# **Report on proposed fire treatment measures and Heritage impacts on ceilings at Corn Exchange Road , Stirling**

ZMARCHITECTURE LTD September 2023 **Revised 26.10.2023, recommendation added**

## **1.0 Purpose of the report**

5.1 Beer store

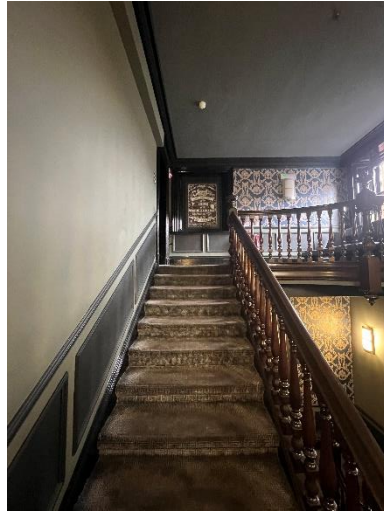
This ceiling has been patched with plasterboard and there is a patch of missing plaster on the lath. It is **not** suitable for the application of intumescent paint and should be fully sheeted with 2 layers of Fireline board.

Suite 05 2<sup>nd</sup> floor en suite

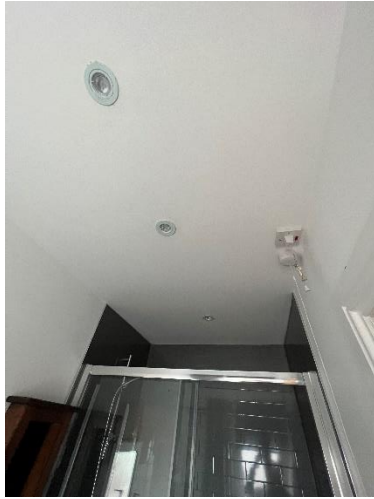
This ceiling is evidently lower than the original ceiling and suspended, it is in good condition but should be double sheeted to maintain 1 hour fire resistance.
